**ADDENDUM NO. 5**  
**to the**  
**PROJECT DOCUMENTS AND SPECIFICATIONS**  
**for**  
**CONSTRUCT OKALOOSA COUNTY WATER AND SEWER**  
**FIELD OFFICES**  
**(ITB WS 02-21)**

**AVCON Project No. 2018.125.02**

**Addendum Date: December 2, 2020**

**ADDENDUM NO. 5**  
**CONSTRUCT OCWS FIELD OFFICES**  
**(ITB WS 02-21)**

**SHEET NUMBER**  
AF2.01

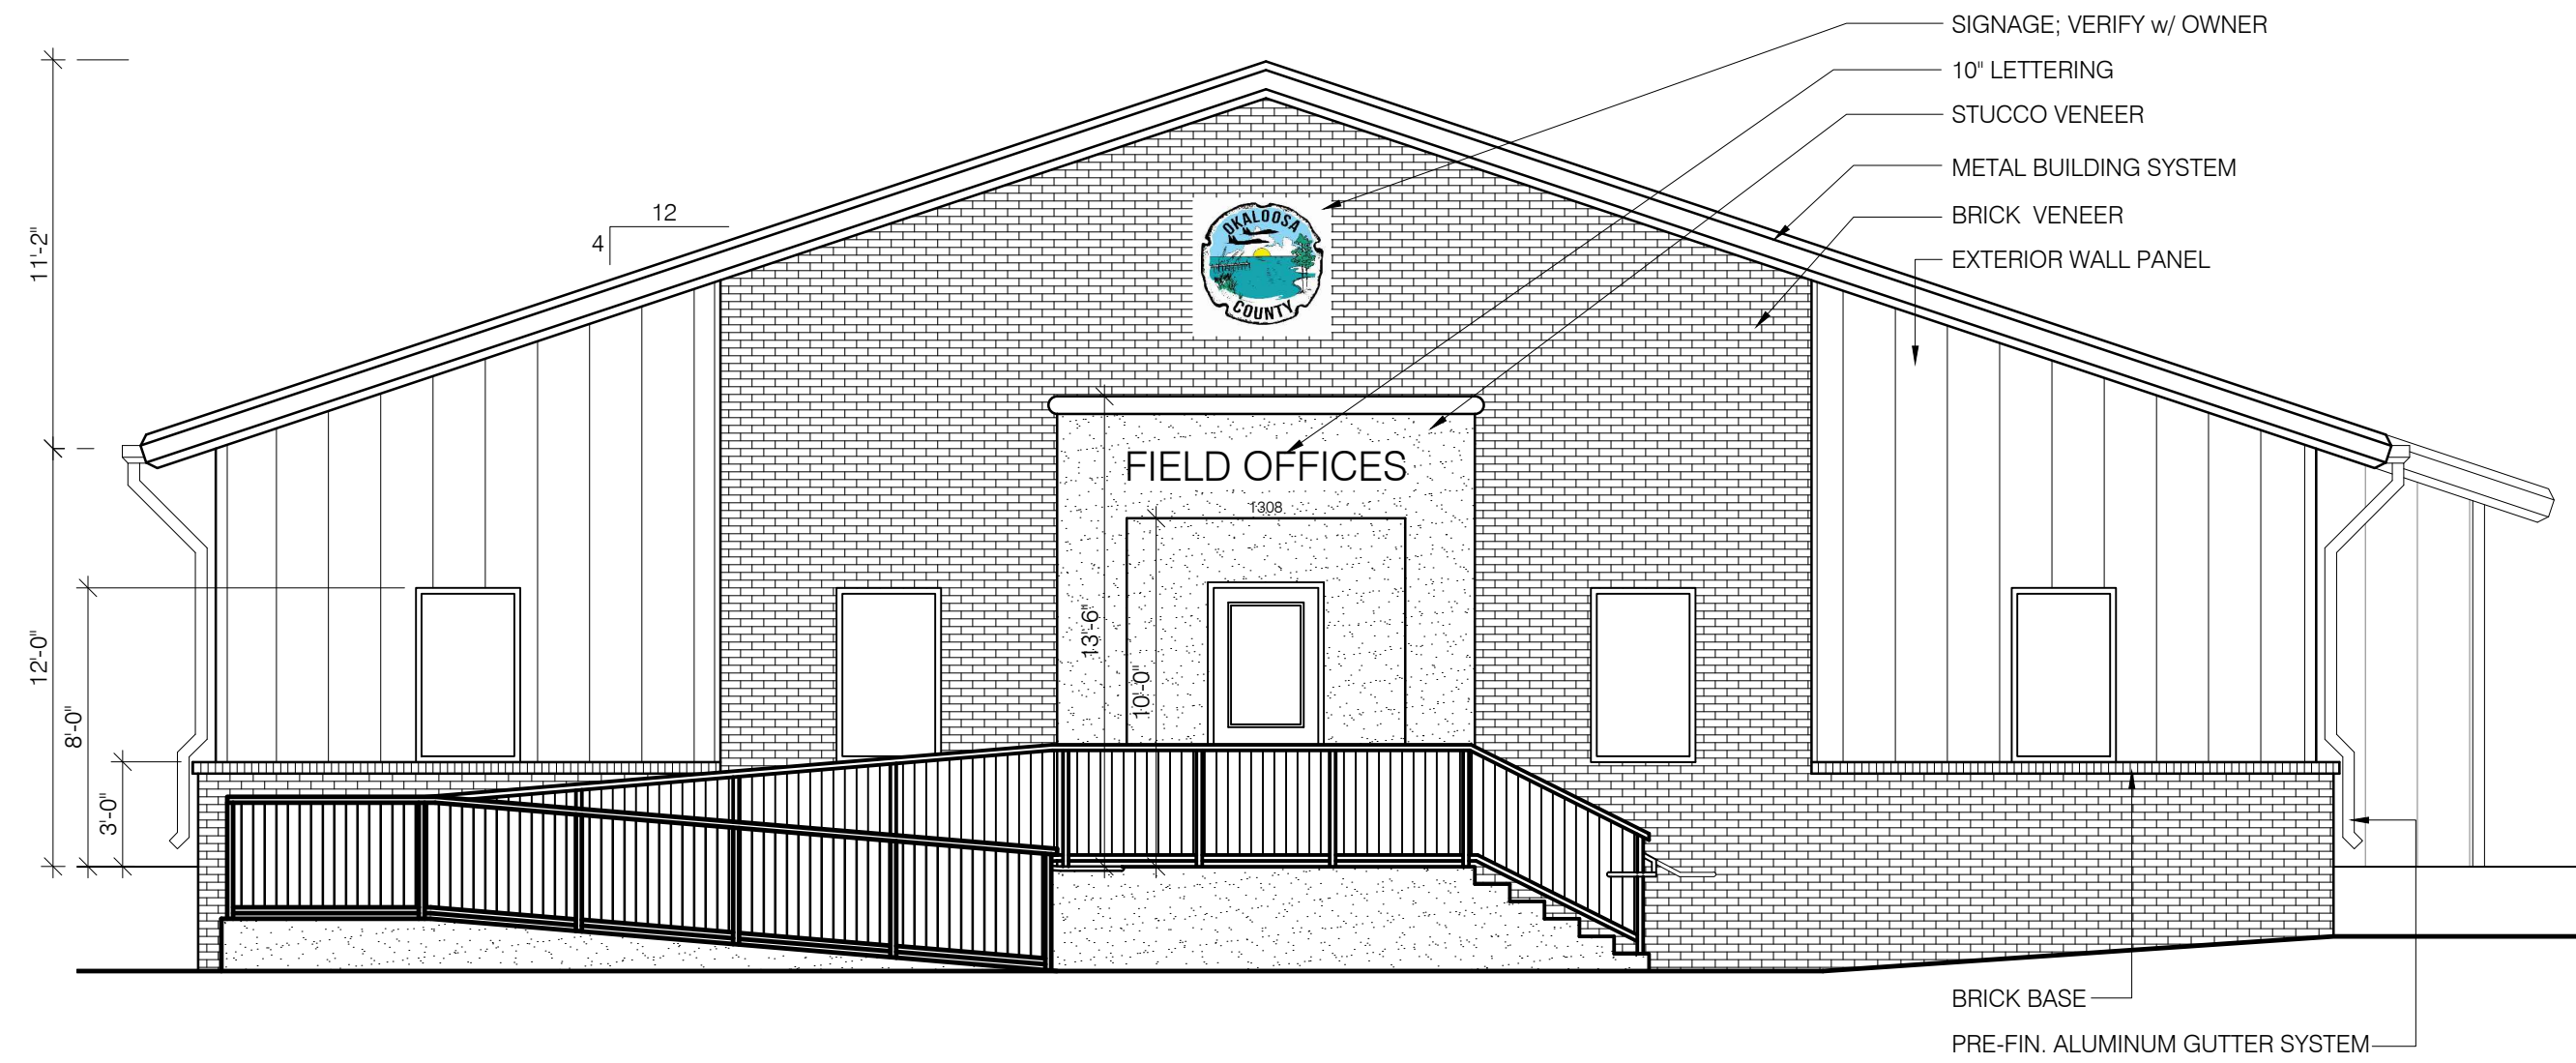
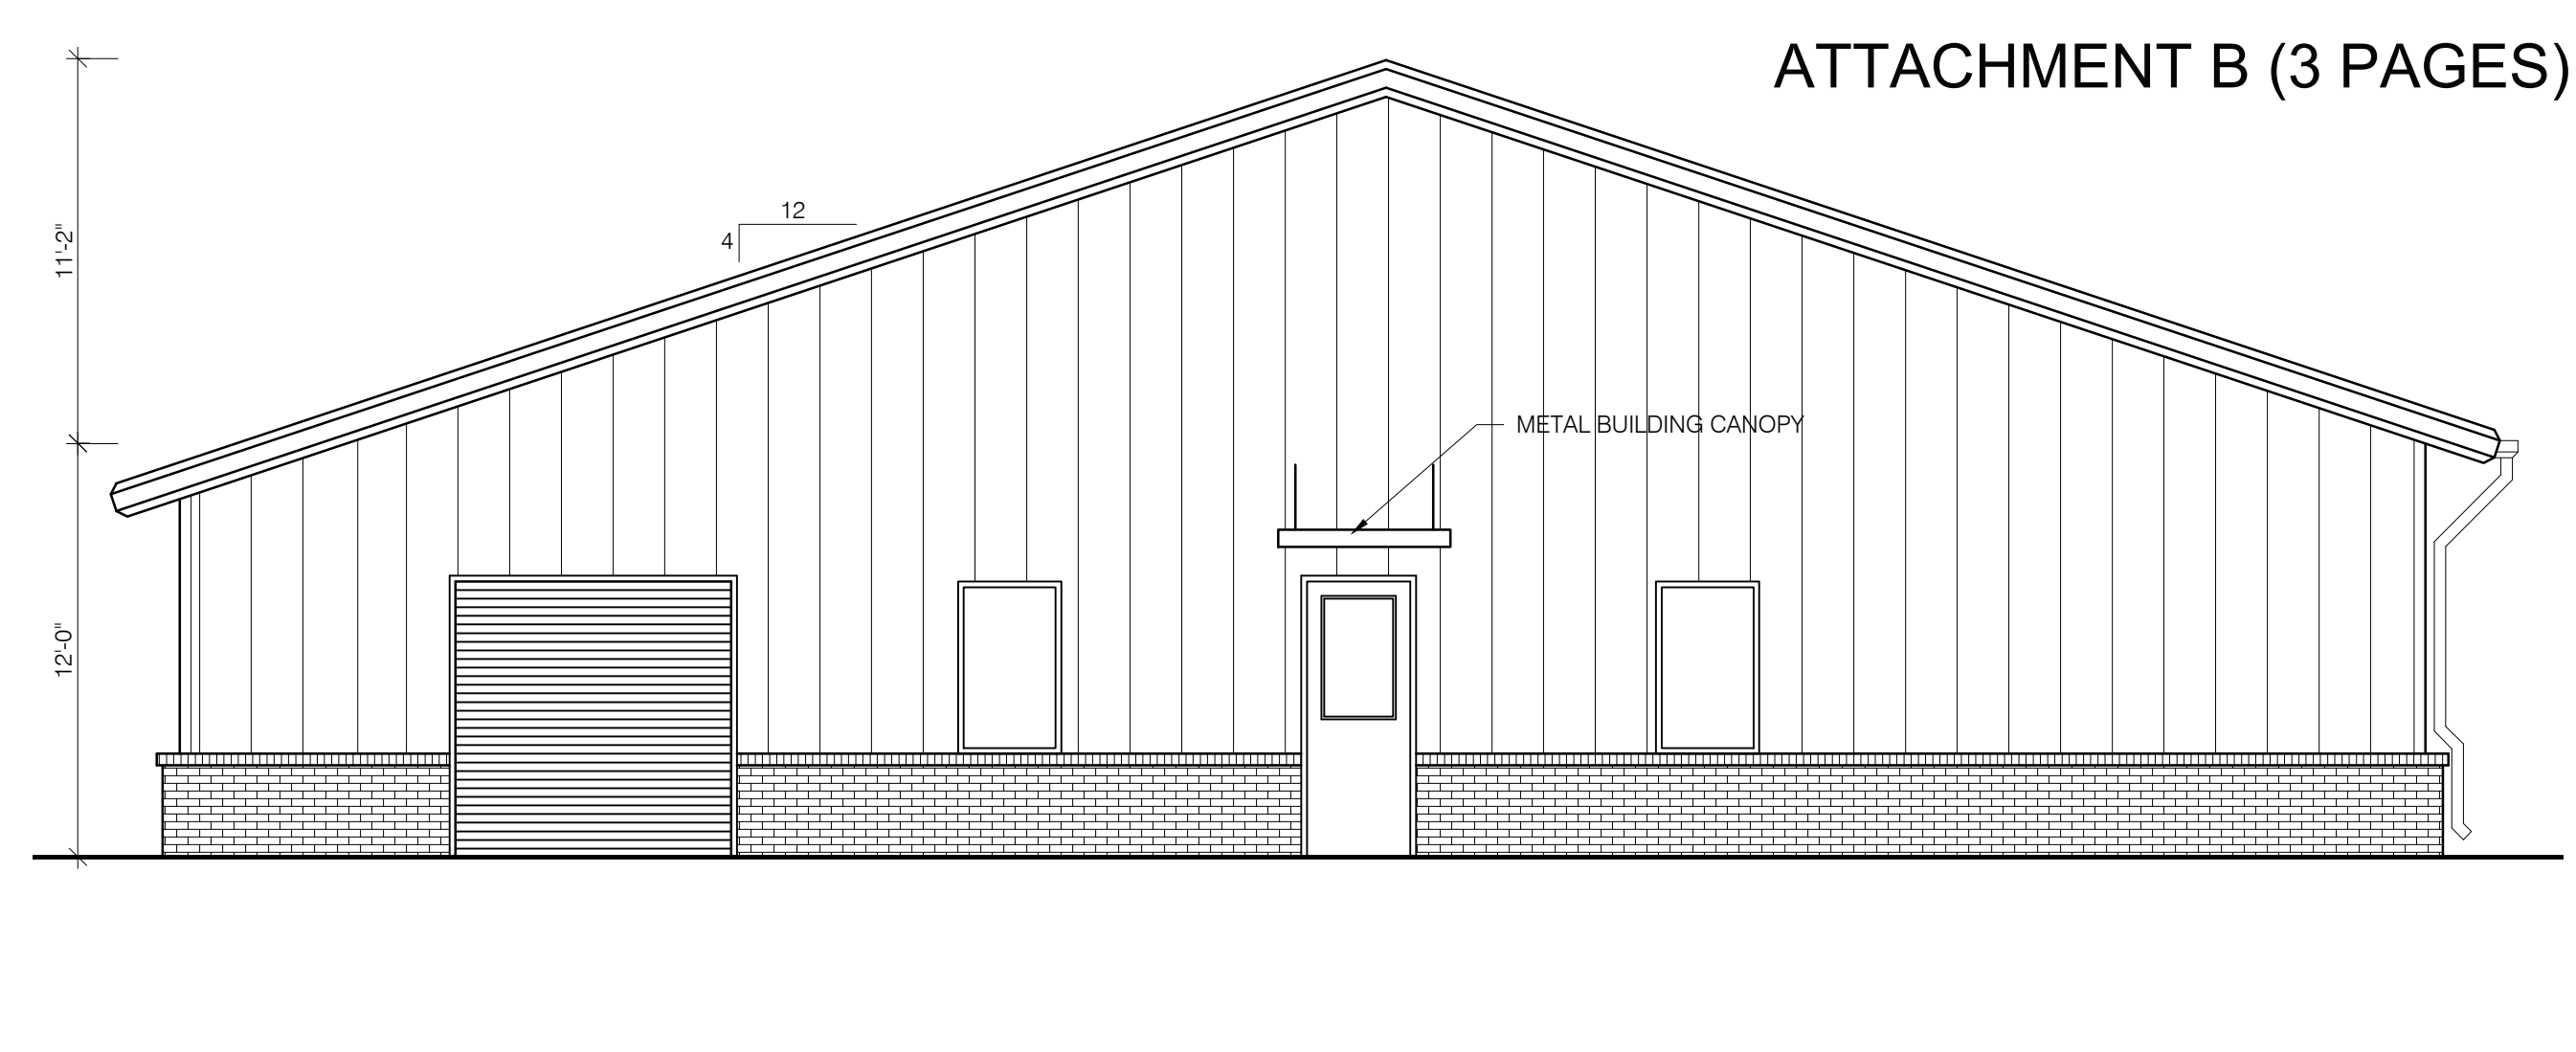
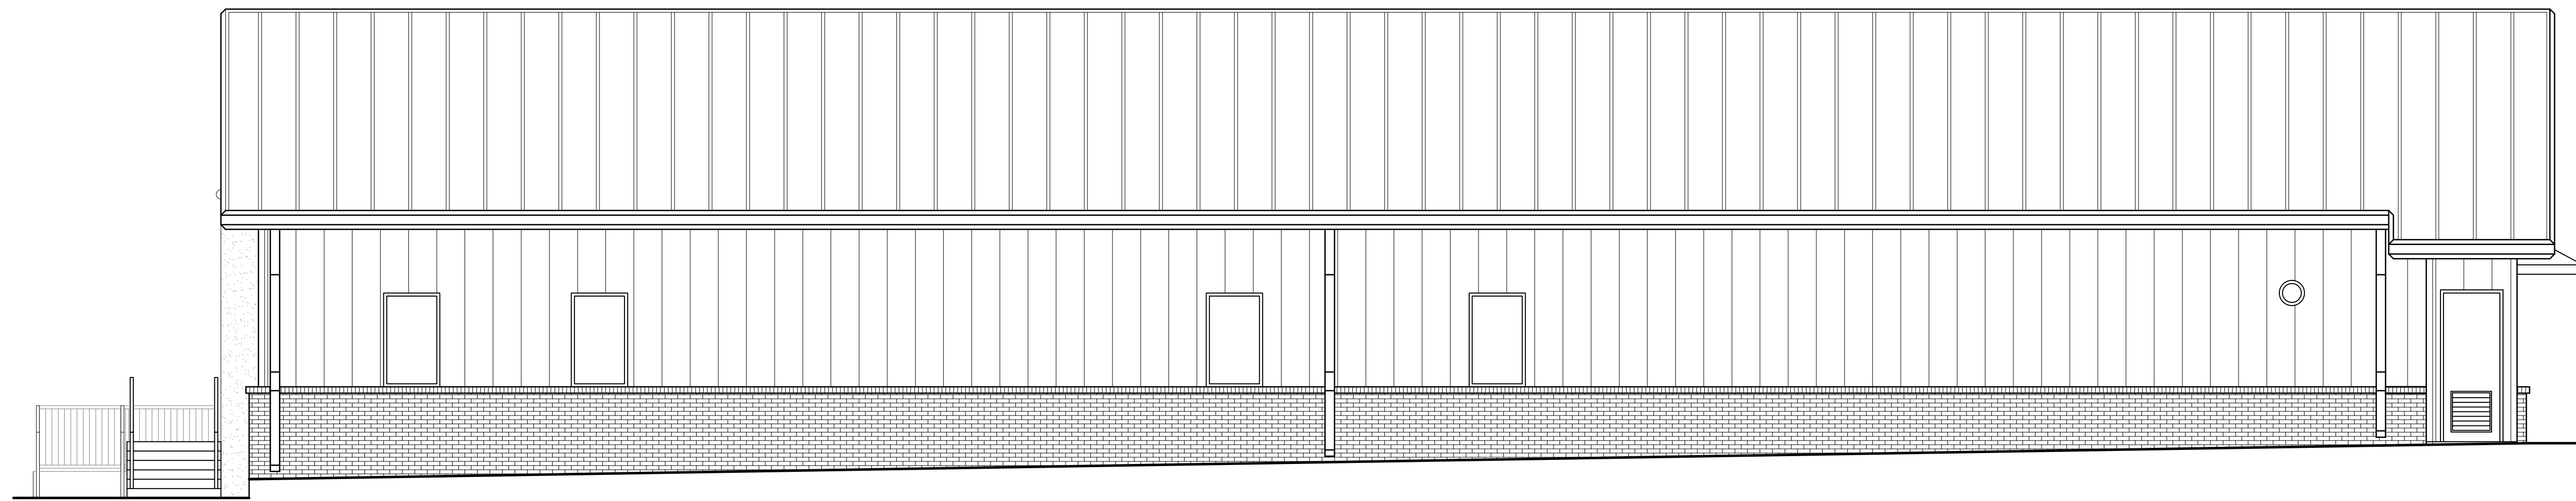
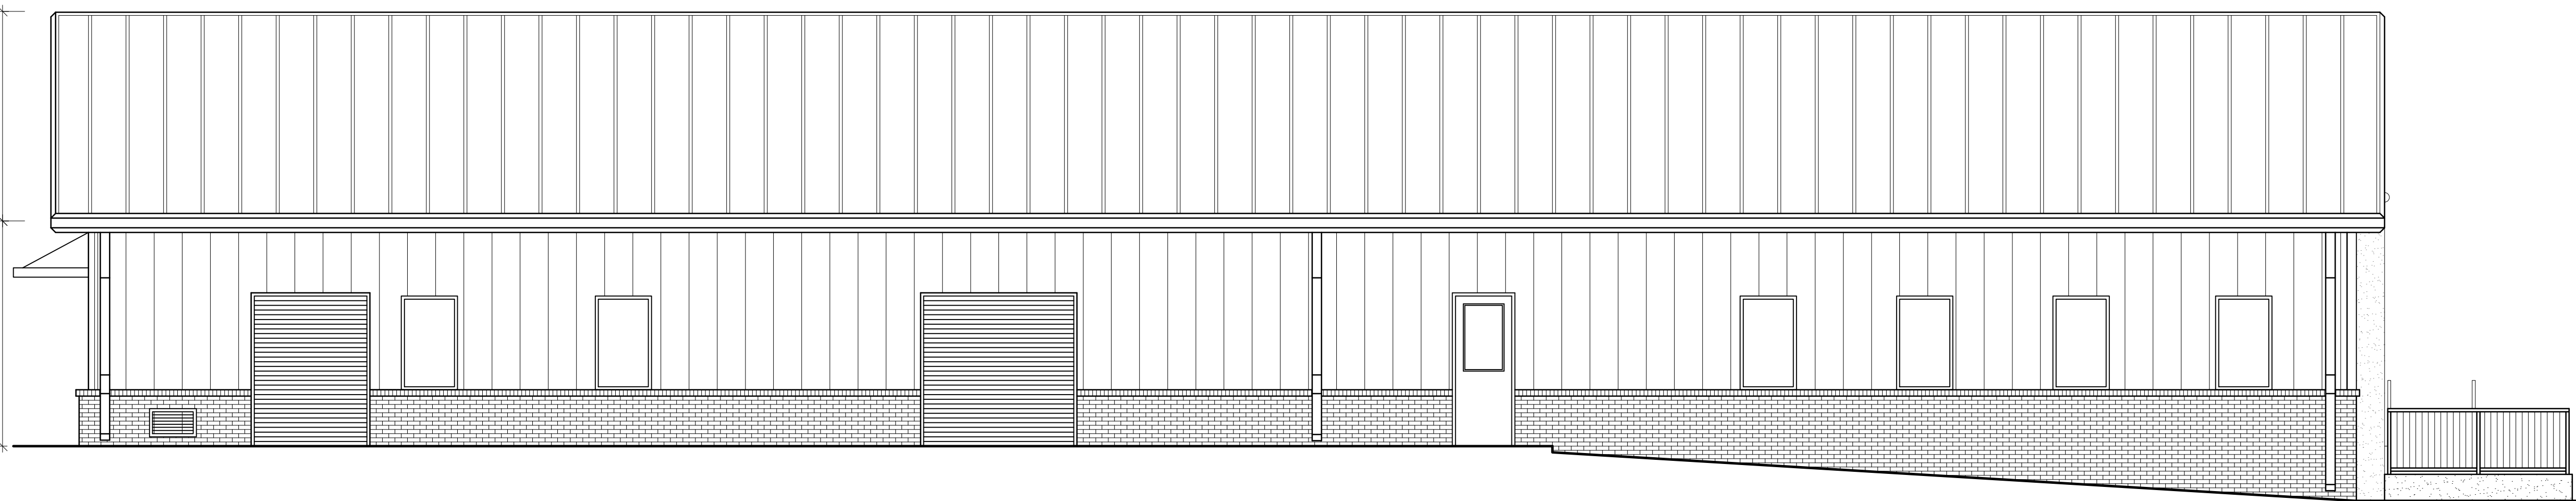
- e. Sheet AF2.01 – What is the Wall Panel Type? If you scale the drawings, it could be an 18" panel or a 36" panel. Please provide a specification, stating Type, Width, Profile, Thickness, etc.

- f. Elevation 4/AF2.01 – does not show the air compressor room or the extended soffit? Please clarify.

- g. Sheet AF2.01 – Elevations 1 & 2 – There are only 2 downspouts show on each elevation. Please clarify that is enough downspouts for a building of this size?

*RESPONSE: 18" standard wall panel*

*RESPONSE: Sheet AF2.01 will be revised in Addendum 5 to show three downspouts on each side of the building.*
